November 5, 1991

Re: ACHCSA Letter of 10/7/91 regarding ARCO Station 276 at 10600 MacArthur Boulevard, Oakland, California.

This letter is an attempt to clarify questions raised in your letter concerning existing off site vapor extraction system and the proposed on site vapor extraction system at the subject site. Items you requested clarification on will be addressed in the order listed in your letter.

FIGURE :  
1  
PROJECT:  
330-40.03

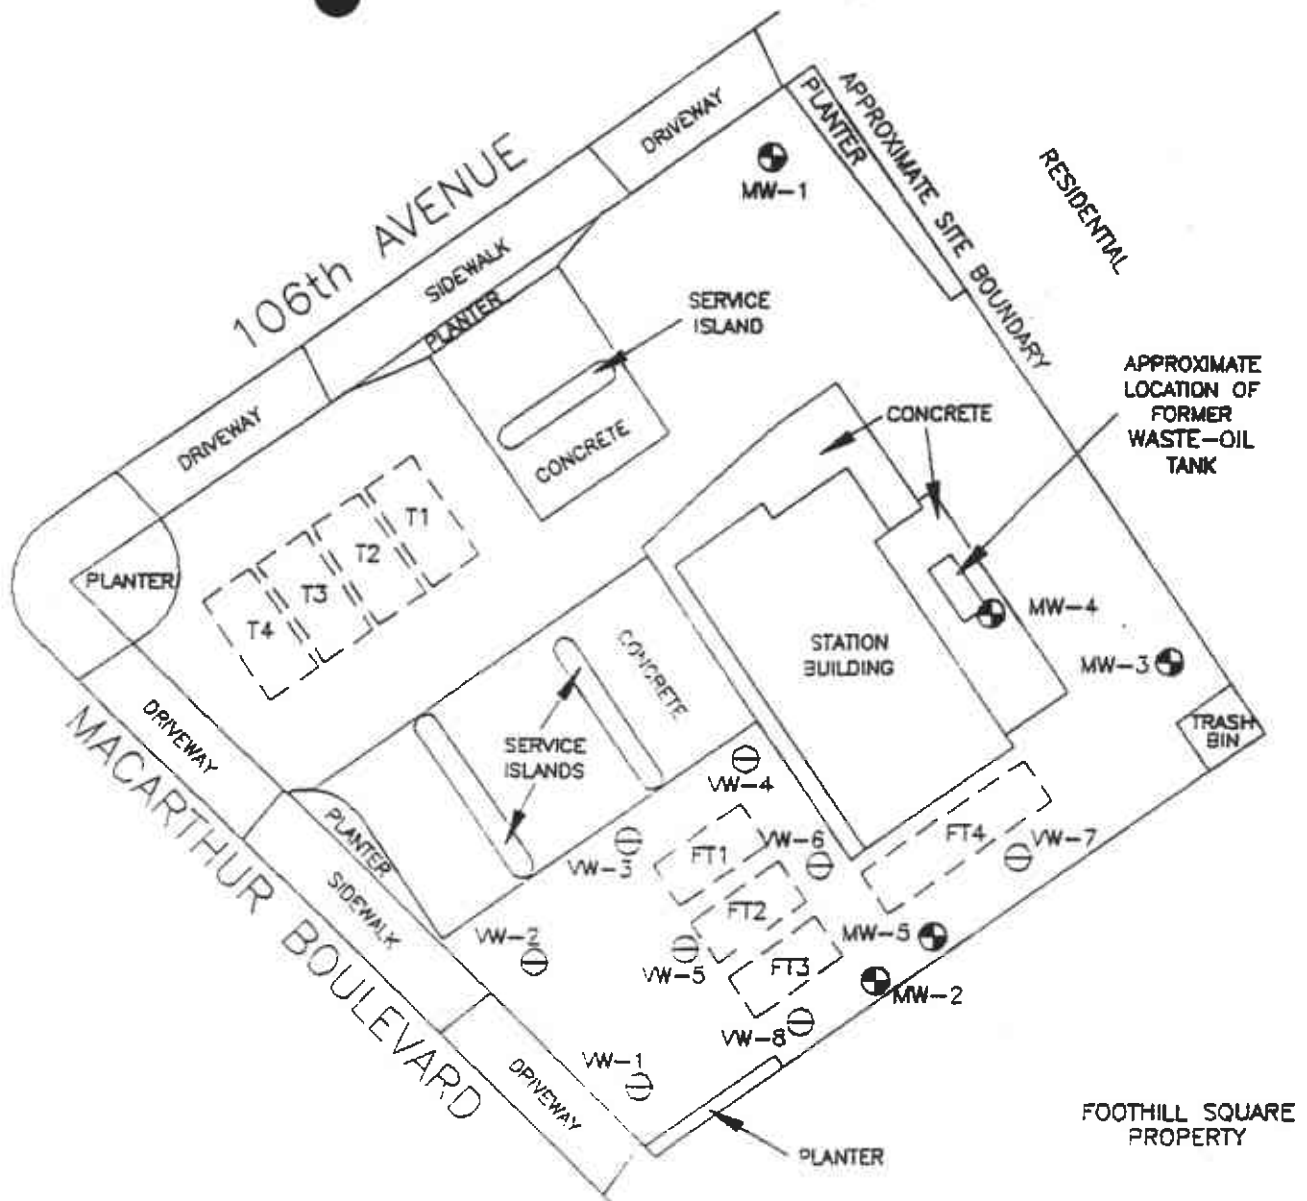
1. You are requested to provide a map indicating the locations of the existing vapor extraction wells also indicating the locations of the proposed vapor and extraction wells. Please also provide a plumbing schematic indicating the locations of all piping connections into and out of the Remedi-cat treatment system.

Figure 1 is a map showing locations of existing vapor extraction wells and probes. Figure 2 is a map showing locations of proposed vapor extraction wells as depicted in the Addendum One to Work Plan (RESNA, June 27, 1991).
